Access Compliance Report

Public Rights-of-Way

(Curb Ramps)

Intersection ID: 46488	Main Street: LAUDER_CT	Cross Street: BALLYBAY_DR	Location: SW
ADA ID: 7D99667142B0	Ramp Type: PerpDiag	Initial Pass/Fail: Fail	Overall Compliance: No
Severity Score: 21.25			
Codes/Mitigation Info/Possible Solution		Field Measurements/Component Compliance

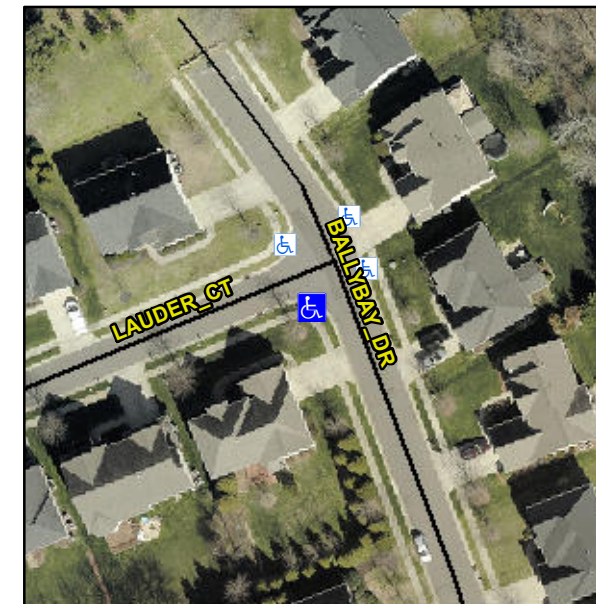
Not Found, R304.5.1, R304.5.3

Compliance	Description	Data	Compliance	Description	Data
N/A	Ramp Length (in)	49.5	Yes	Ramp Slope (%)	5.2
No	Ramp Width (in)	43.0	No	Ramp XSlope (%)	6.4
N/A	Flare Type LT	N/A	N/A	Flare Type RT	N/A
N/A	Flare Slope LT (%)	N/A	N/A	Flare Slope RT (%)	N/A
N/A	Flare Traversable LT?	N/A	N/A	Flare Traversable RT?	N/A
N/A	Landing Length (in)	N/A	N/A	DWS Provided?	N/A
N/A	Landing Width (in)	N/A	N/A	DWS Contrast?	N/A
N/A	Landing Slope (%)	N/A	N/A	DWS Length (in)	N/A
N/A	Landing X Slope (%)	N/A	N/A	DWS Full Width?	N/A
N/A	Landing Curb? (Y/N)	N/A	N/A	DWS Offset (in)	N/A
N/A	Shared Landing?	N/A			
N/A	Gutter Ponding?	N/A	N/A	Gutter Slope (%)	N/A
N/A	Gutter Lip Ht (in)	N/A	N/A	Gutter X Slope (%)	N/A
N/A	Painted X Walk1?	No	N/A	Painted X Walk2?	No
	X Walk 1 Direction	To NE		X Walk 2 Direction	To NW
N/A	X Walk 1 Width (in)	N/A	N/A	X Walk 2 Width (in)	N/A
	X Walk 1 Slope (%)	7.9		X Walk 2 Slope (%)	2.8
	X Walk 1 X Slope (%)	2.7		X Walk 2 X Slope (%)	7.2

N/A	Ramp inside XWalk1?	N/A	N/A	Ramp inside XWalk2?	N/A
	Road Slope (%)	7.3	N/A	Clear Space?	N/A
	Road X Slope (%)	5.9	N/A	Clear Space to XWalk (in)	N/A
N/A	Any Obstructions?	N/A	N/A	Storm Grate/Utility Hazard?	N/A
	Obstruction Type			Storm Grate/Utility Type	
		N/A			N/A
		Yes		Surface Condition? (G/P)	Good

Remove & Replace Curb Ramp With Two New Directional Ramps or Equivalent.
